**Re: Development Projects Proposed at 2166 and 2172 Stanley Hills
Drive, ZA-2025-1386-CU-HCA and ZA-2024-6711-CU-HCA; ENV-2024-
6712-CE**

Exhibit 1
Overview of Deficiencies

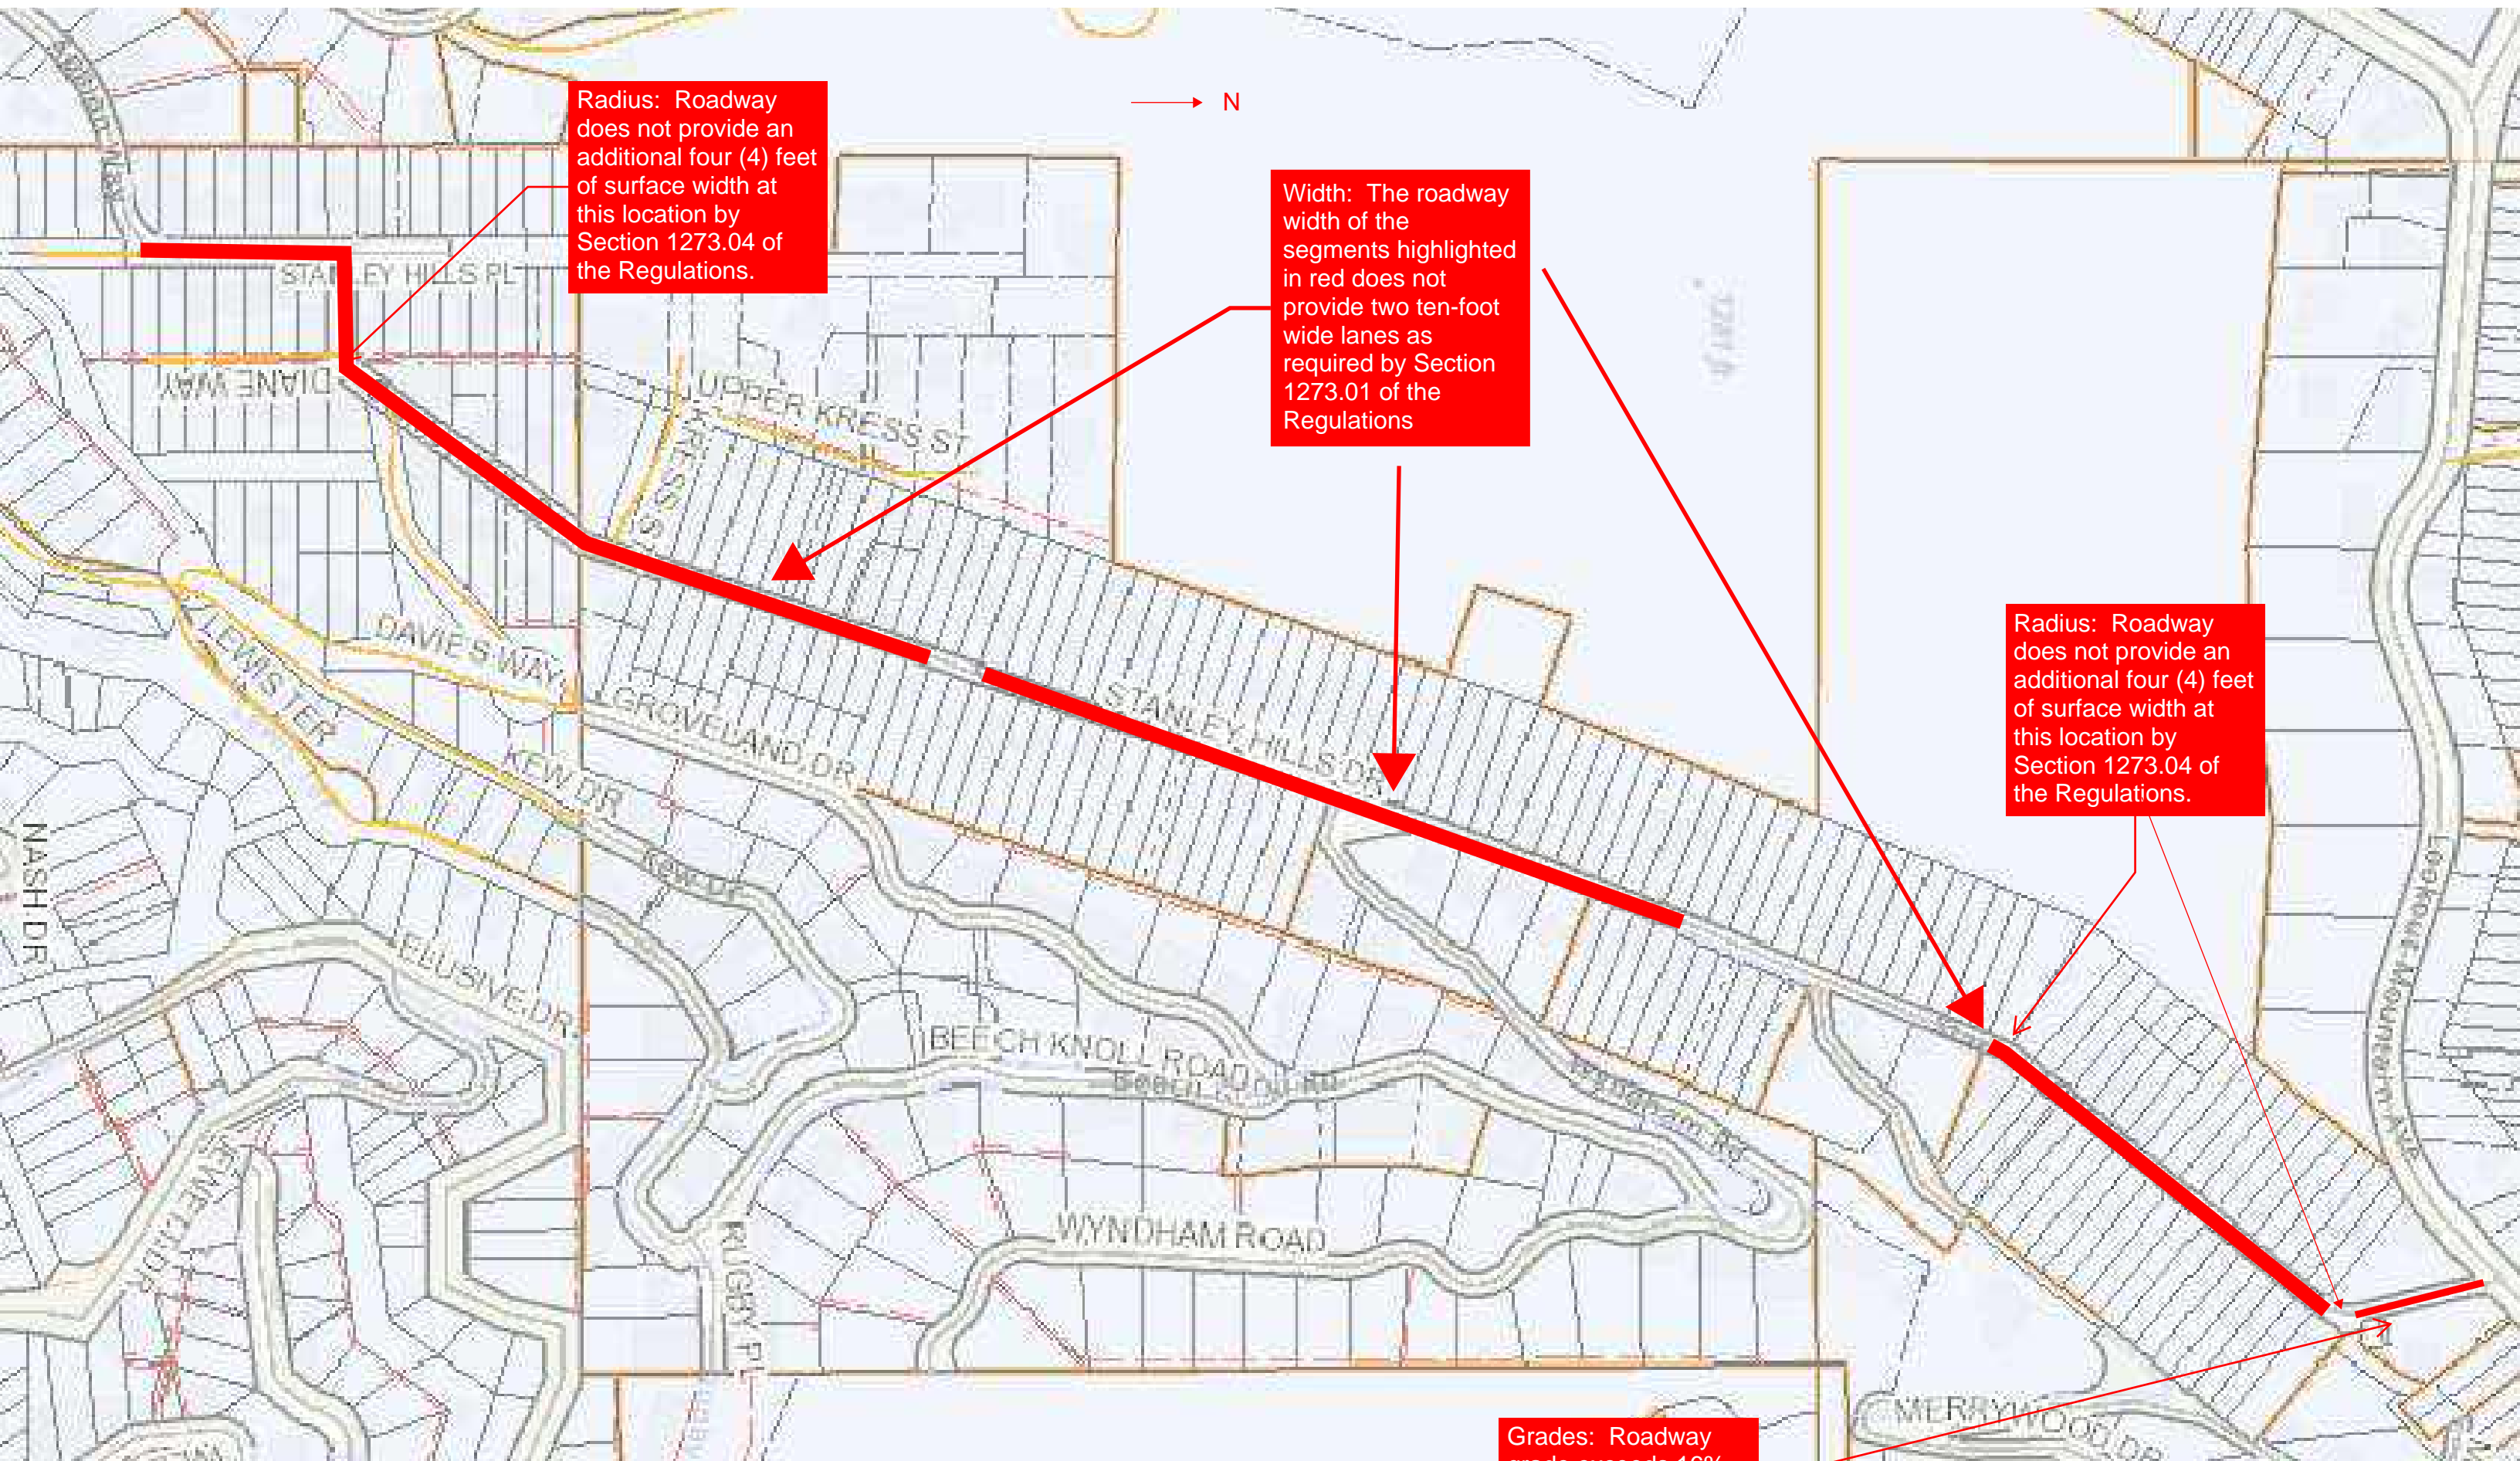
Radius: Roadway does not provide an additional four (4) feet of surface width at this location by Section 1273.04 of the Regulations.

Width: The roadway width of the segments highlighted in red does not provide two ten-foot wide lanes as required by Section 1273.01 of the Regulations

Radius: Roadway does not provide an additional four (4) feet of surface width at this location by Section 1273.04 of the Regulations.

Sheet Index No. P-2383

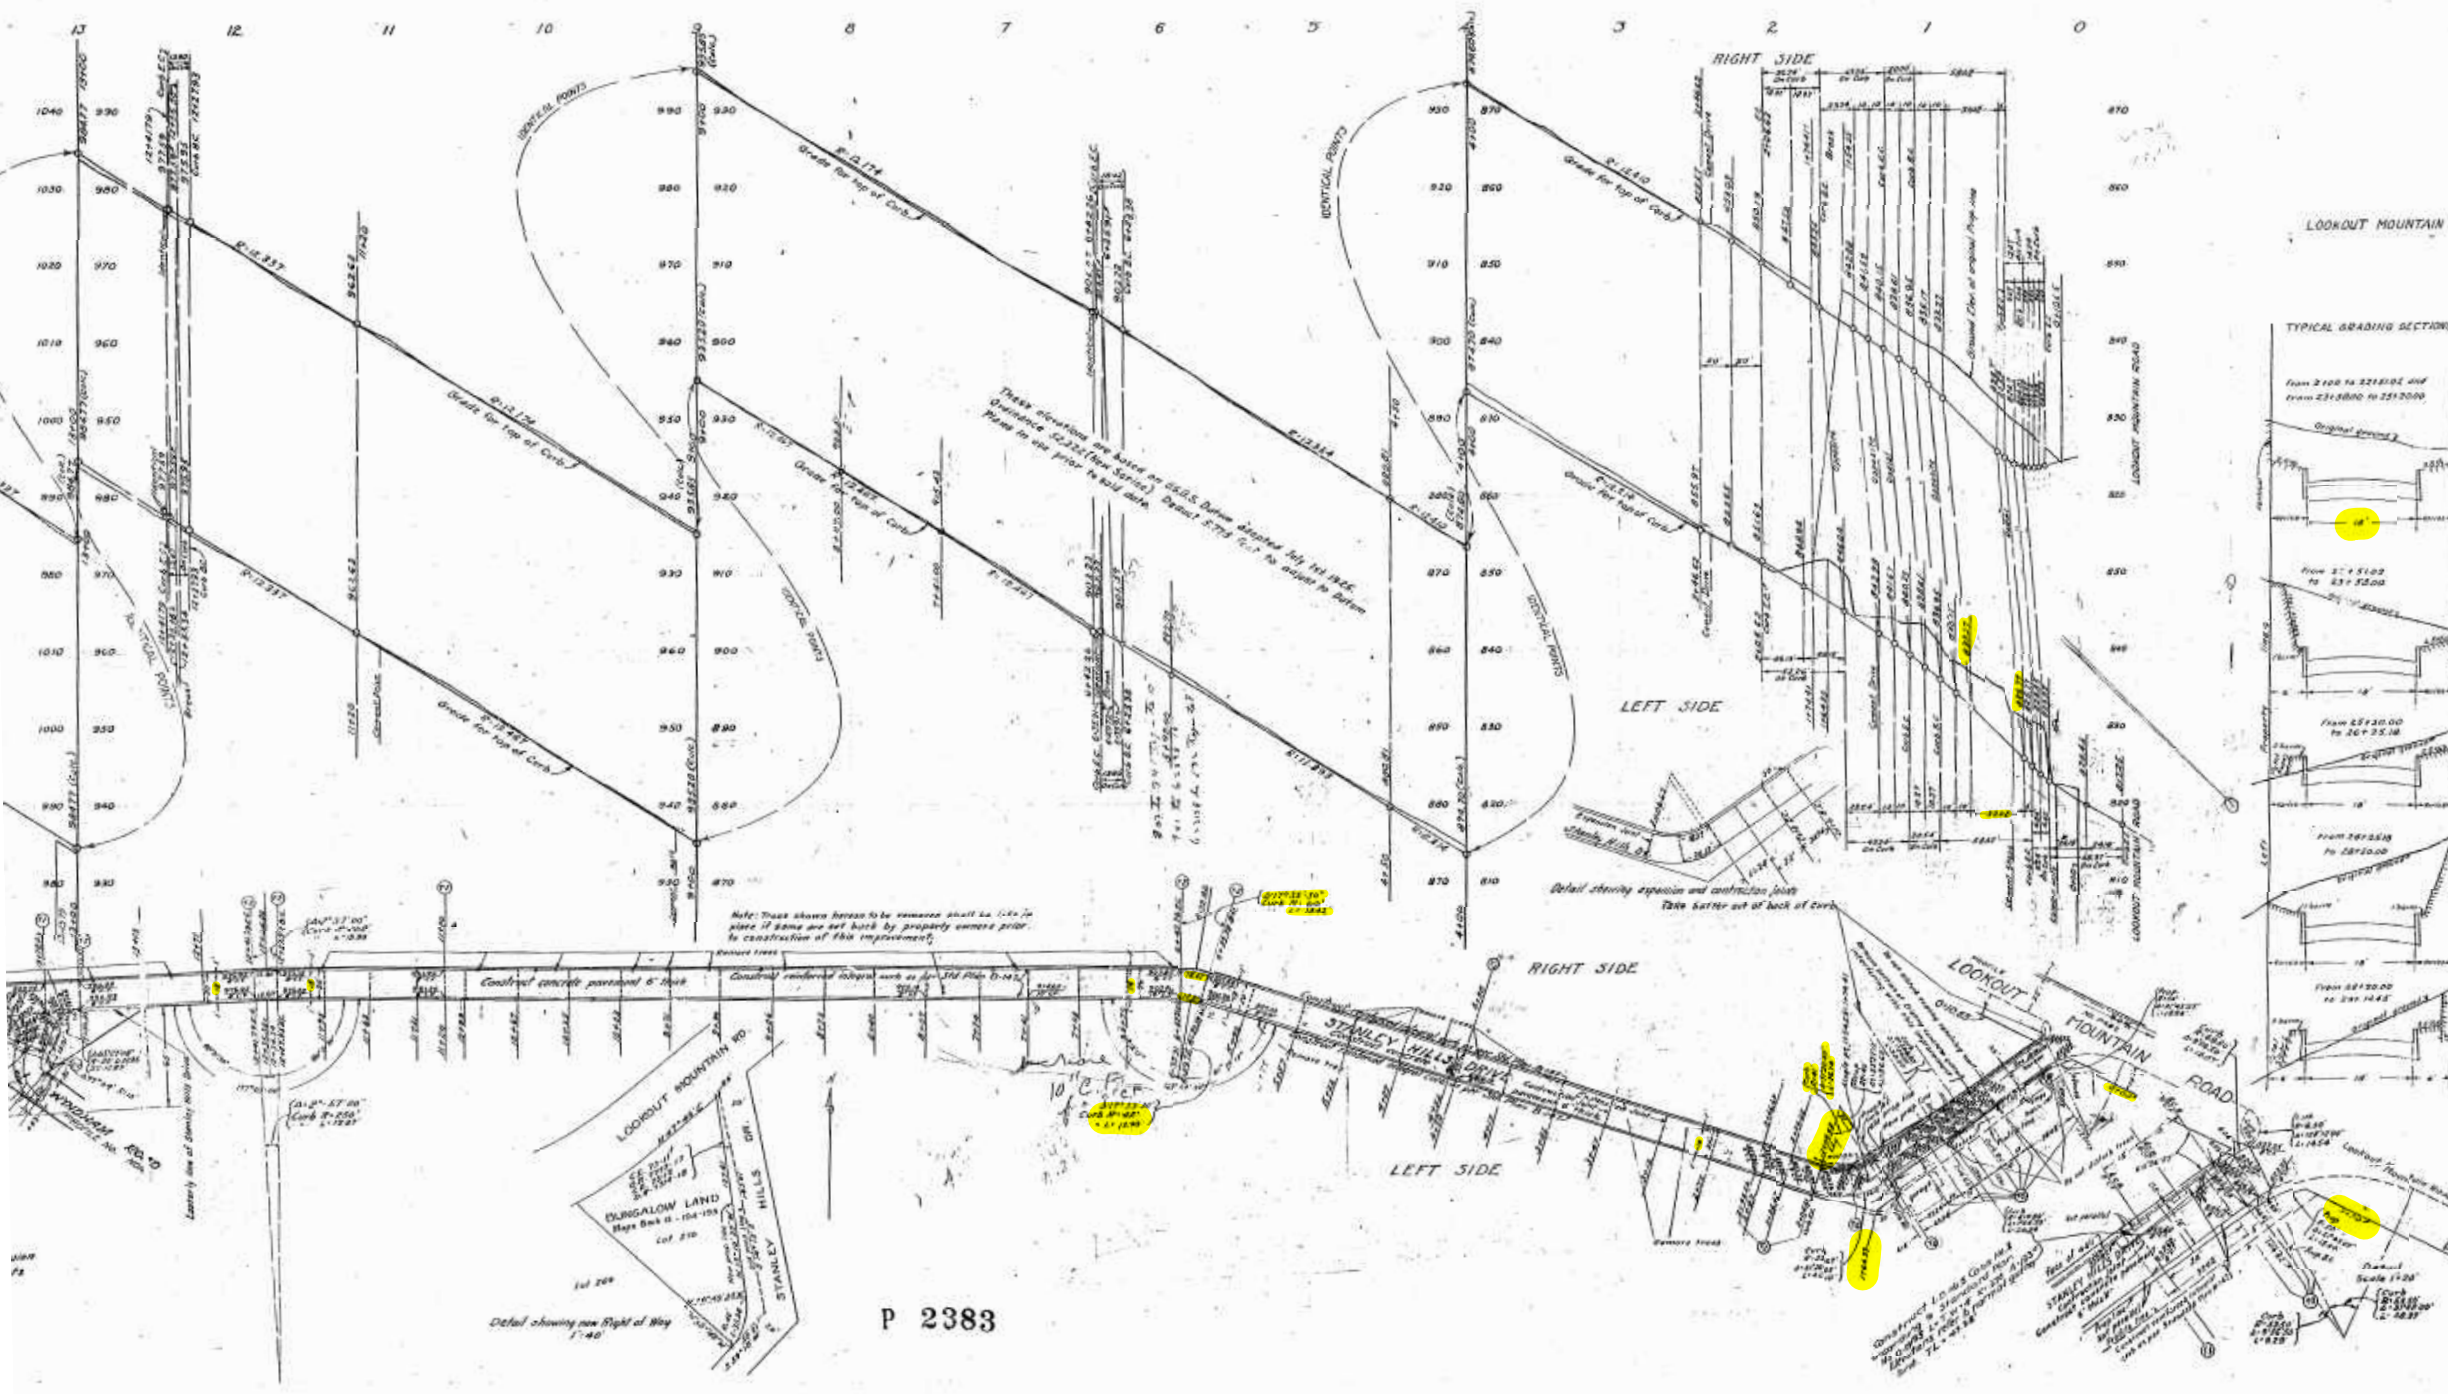
The City's as-built plans for Stanley Hills Drive show its cross section as 18' wide measured from curb face to curb face. See the "Typical Grading Sections" on Sheet Index No. P-2383 in **Exhibit 2.1** for a cross section of Stanley Hills Drive that shows its width as 18' wide from curb face to curb face. Multiple measurements of the width taken along Stanley Hills Drive confirms that Stanley Hills Drive measures 18 feet wide for virtually its entire length². The City's own Administrative Review and Checklist for the Projects show that they are aware that Stanley Hills Drive is less than 20 feet in width.

Sheet Index No. P-2383, show the three curves mentioned under the Existing Conditions section of this Report and images from those curves are provided in **Exhibits 4.1, 4.2, and 4.3**.

Measurements taken in the field demonstrate that each curve is less than 100 feet in radius yet the roadway width around those curves remains constant at 18 feet and does not provide an additional surface width of four (4) feet.

Exhibit 4.1: Screenshot from Sheet Index No. P-2383 Showing Curve That Ends at Station 2+06.62

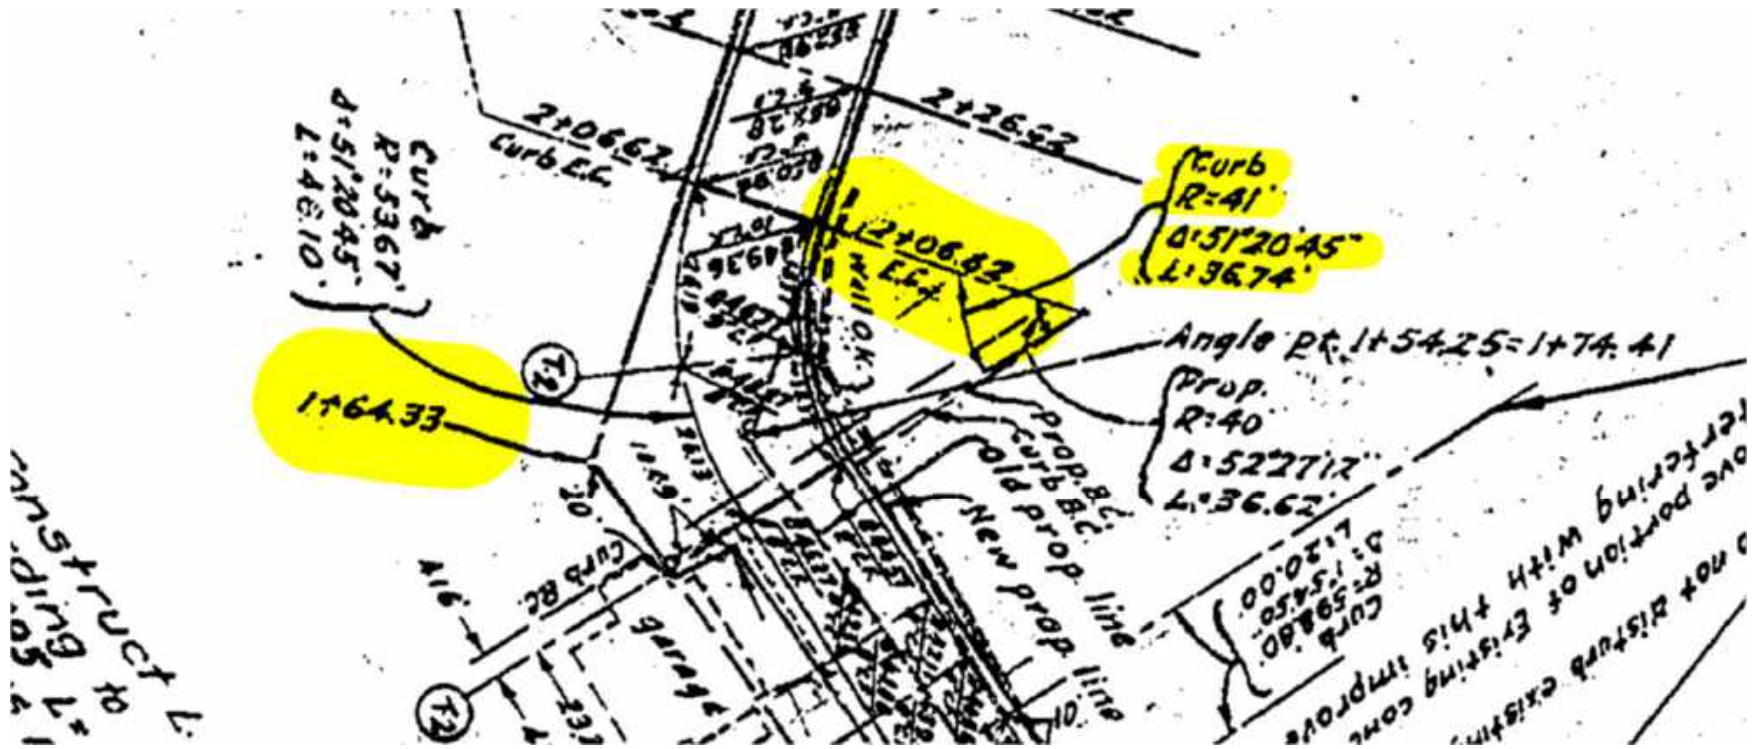
Since the width of Stanley Hills Drive does not provide an additional surface width of four (4) feet along these curves, Stanley Hills Drive does not meet the Regulations' requirements with respect to radius and, consequently, does not comply with LAMC Section 57.4908.
